**RE: COMMERCIAL FINAL DEVELOPMENT PLAN
LEE'S SUMMIT HIGH SCHOOL ADDITION AND RENOVATION
LEE'S SUMMIT, MISSOURI**

Kaw Valley Engineering, Inc. (KVE) has received comments from City of Lee's Summit for the above referenced project on December 9, 2020 and issues the following response.

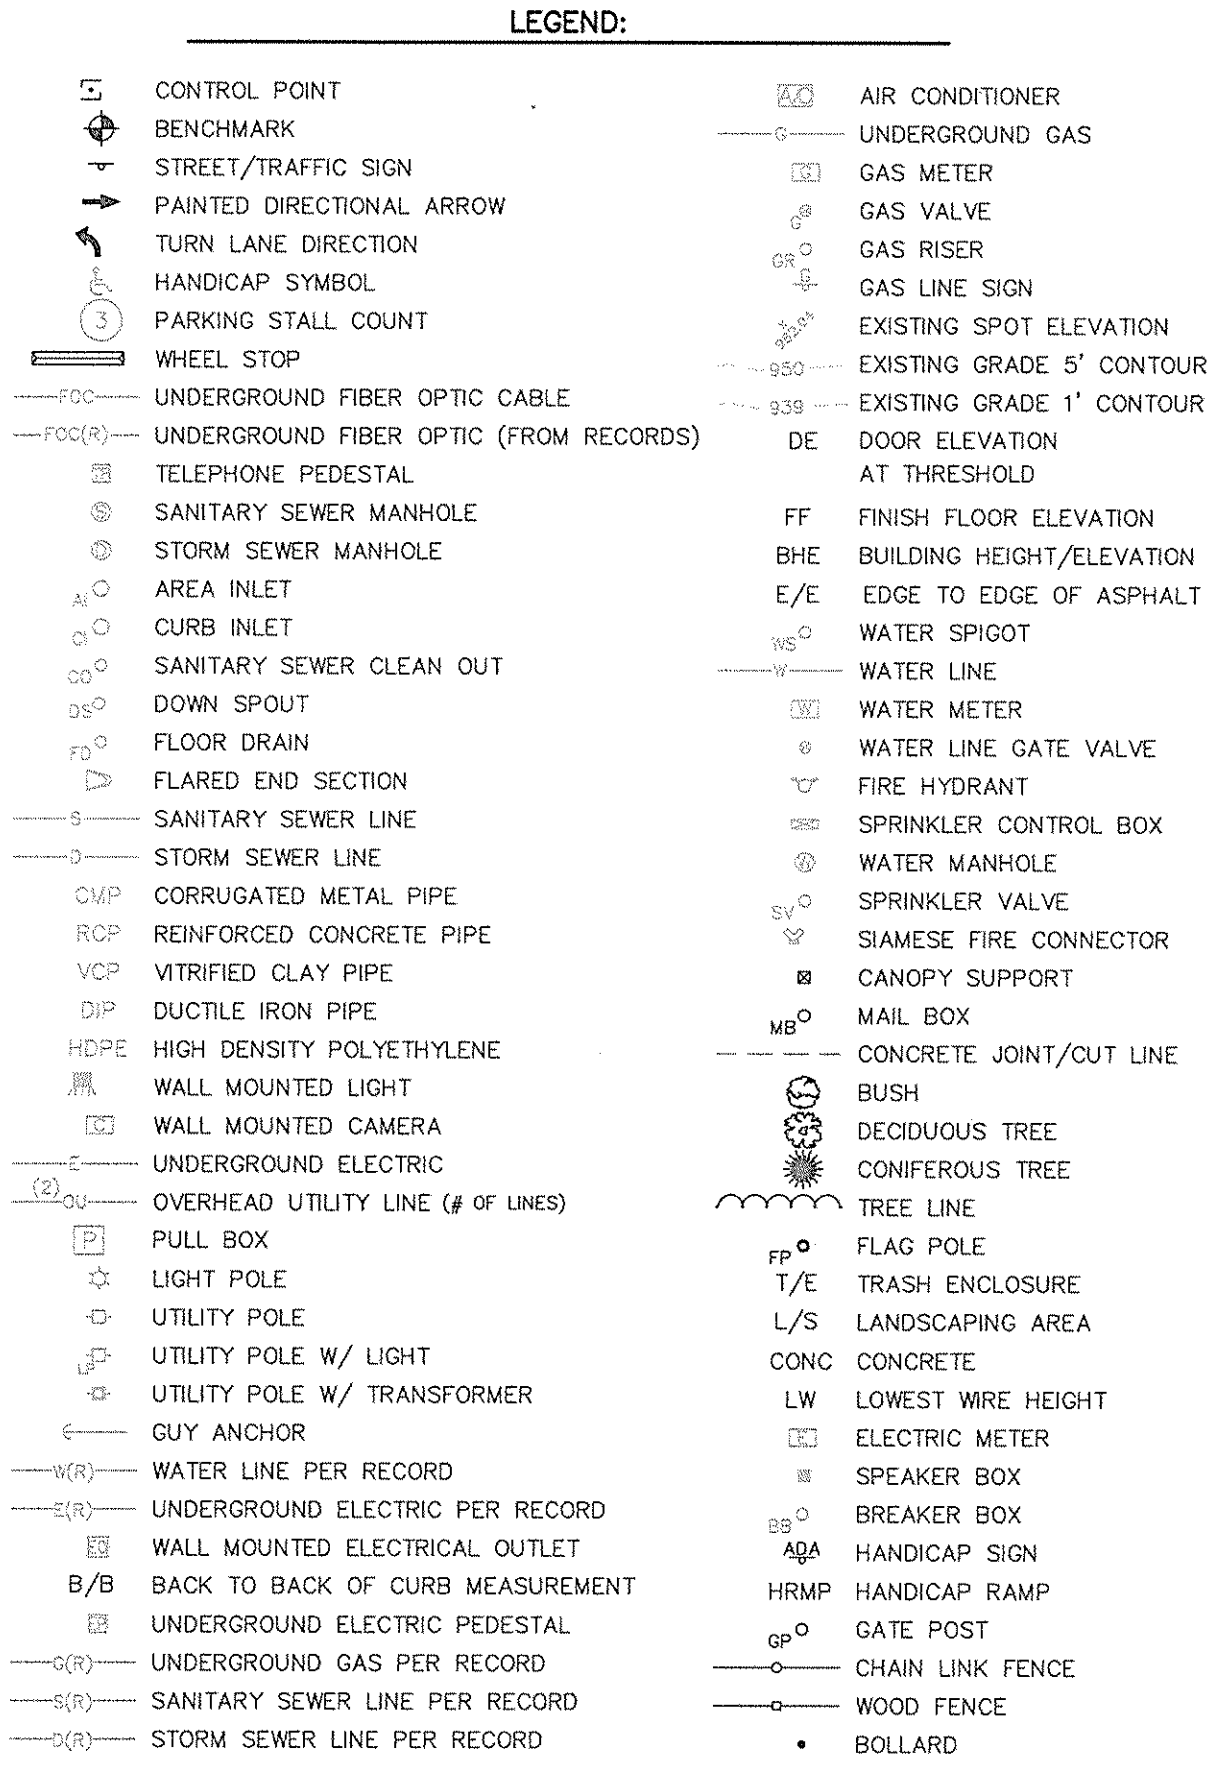
Comment 1: The public sanitary sewer running from the Highway Patrol property to City Manhole #39-155 should be designated as private to avoid conflicts with construction. This would require a new public sanitary sewer extension to the Highway Patrol property from the public sanitary sewer located in the northeast portion of the high school property. **I have attached the topographic and boundary survey with sanitary sewer overlay as well as the GIS map from the City of Lee's Summit. Per the O&E report referenced on the boundary survey, the sewer line that runs from manhole #39-155 to the Highway Patrol property appears by all accounts to be private. If this line is public, the City of Lee's Summit will need to provide a copy of the recorded easement dedicating the sanitary sewer to the City. Unless provided additional documentation that a title search did not find, I do not believe there is an easement to vacate. As discussed on December 10, 2020, it is our understanding that the Lee's Summit School District and Highway Patrol will enter into an agreement to permit the existing connection to the LSSD private sanitary sewer line that is valid until such time that the Highway Patrol site is redeveloped. Also, it is our understanding that the LSSD will execute an agreement with the City of Lee's Summit to permit the extension of a Public Sanitary Sewer line across the east side of the LSHS campus at such time that the Highway Patrol site is redeveloped. The developer of the Highway Patrol site will be financially responsible to remove the existing service line connection from the LSSD private sanitary line as well as the cost to install the new sanitary sewer main and incidental construction to repair/restore LSSD to install said sewer line. In addition, a portion of the sanitary sewer 39-041 to 39-039 should also be dedicated as private. As discussed on December 10, 2020, the existing sewer line in question is currently private.**

Comment 8: Portions of utility easements should be vacated for those portions of the sanitary sewer line to be dedicated as private. Please see comment number 1 for specific information concerning these vacates. **There is no record that existing sanitary sewer system on the Lee’s Summit High School Campus proper was dedicated to the City of Lee’s Summit and encumbered by easement as discussed on December 10, 2020. No vacations will be submitted.**
